THE MARYLAND-NATIONAL CAPITAL PARK & PLANNING COMMISSION

MEMORANDUM

REVIEW TYPE: Site Plan Review
APPLYING FOR: Approval of 189 multifamily units
PROJECT NAME: **Creekside at Rossmoor Leisure World**
CASE #: 8-04030
REVIEW BASIS: Site Plan Review required for the PRC Zone [§59-C-7.49(b)]
ZONE: Planned Retirement Community Zone
LOCATION: Leisure World Boulevard and Pine Orchard Drive, 1375 feet east of Gleneagles Drive
MASTER PLAN: Aspen Hill
APPLICANT: Rossmoor – IDI Overlook, L.P.
FILING DATE: April 26, 2004
HEARING DATE: July 29, 2004

Landscape Plan for Creekside showing the stream valley buffer (red line), forest conservation (dark green), wetlands (blue), the sidewalks (yellow), the nature trail (orange), the limits of disturbance (black dotted line).

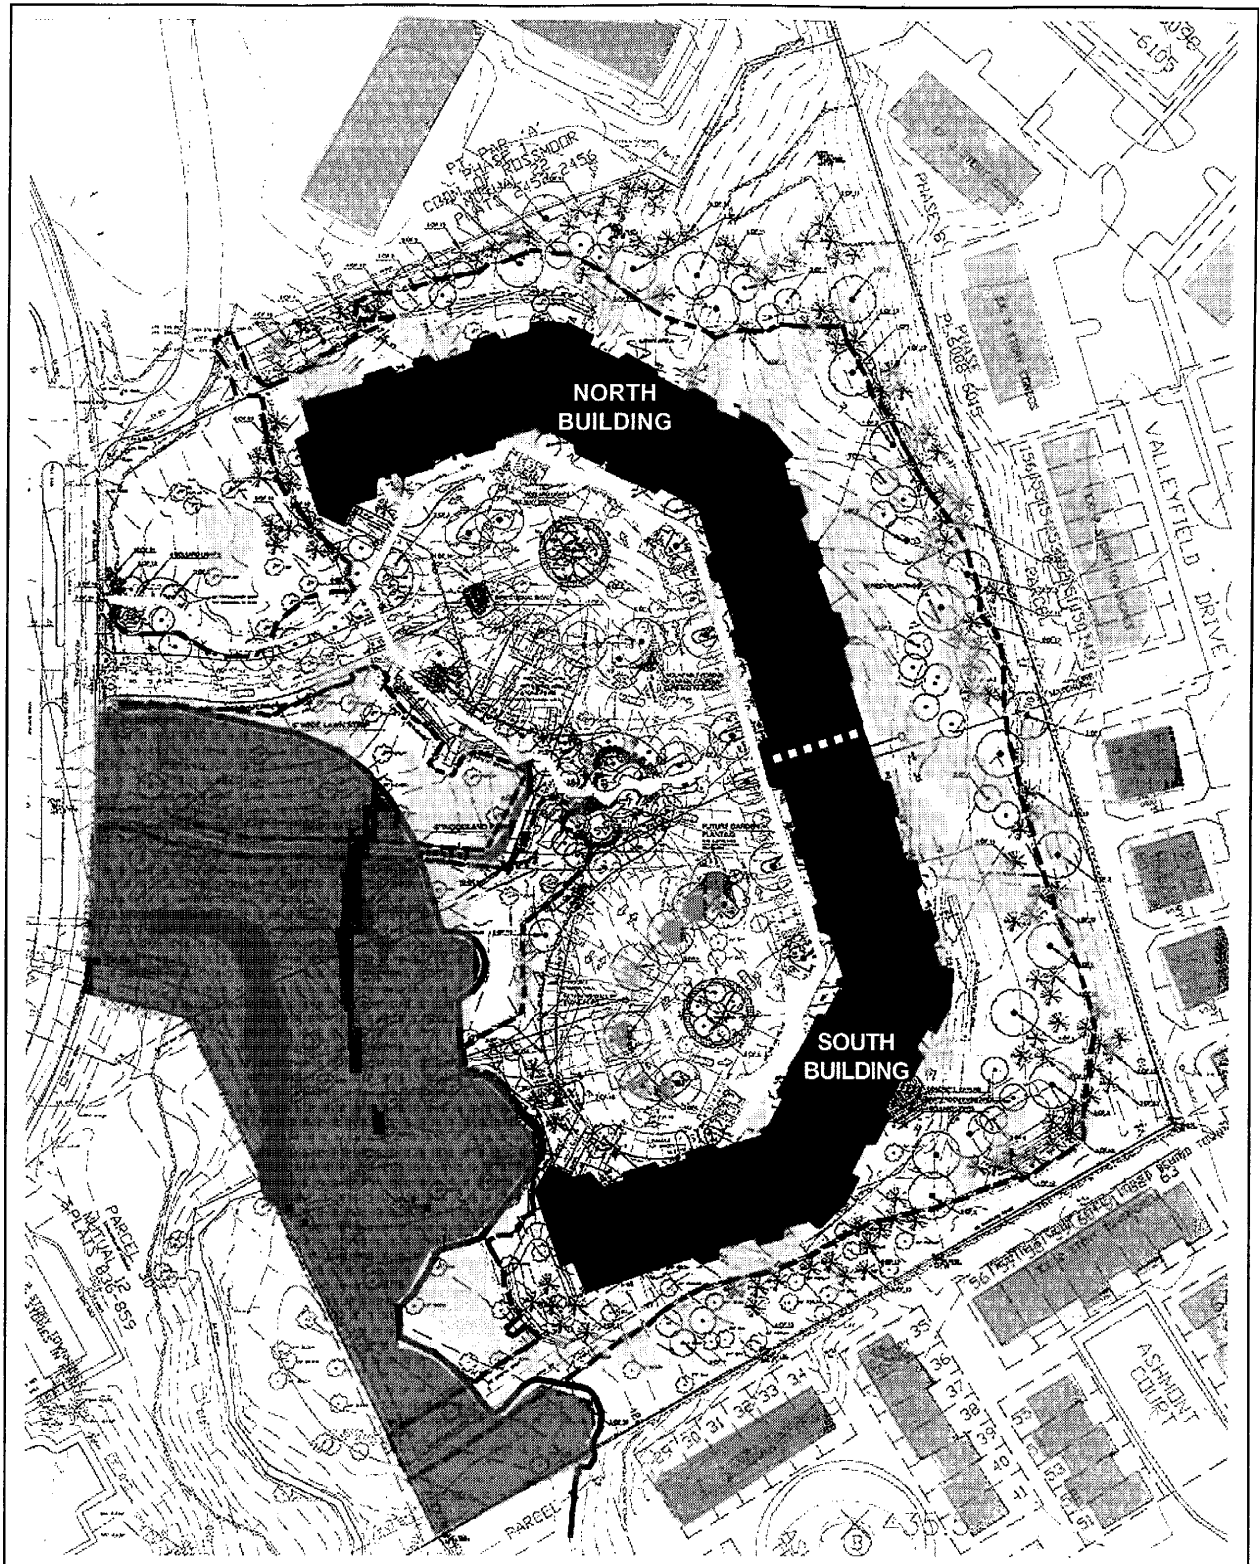
- a. Site Plan
 - i. Show Forest Conservation easements on all drawings sheets;

- ii. Label **building heights**, building and parking **setbacks** at all property lines and parcel boundaries;
 - iii. Denote methods and locations of **tree protection**;

- vi. Delete parking spaces labeled “future possible parking” from plan;
 - vii. Verify that five feet clear sidewalk width is provided for all sidewalks; verify that sidewalks adjacent to head-in parking are minimum 7 feet in width;

- viii. Show bus or transit stops on plan;
 - ix. Show LODs, all easements, road dedications, crosswalks; show square footage for all parcels of green space;

- b. Landscape Plan
- i. Show details and materials for all retaining walls and terraces; all retaining walls must be constructed of masonry materials; show top and bottom elevations;
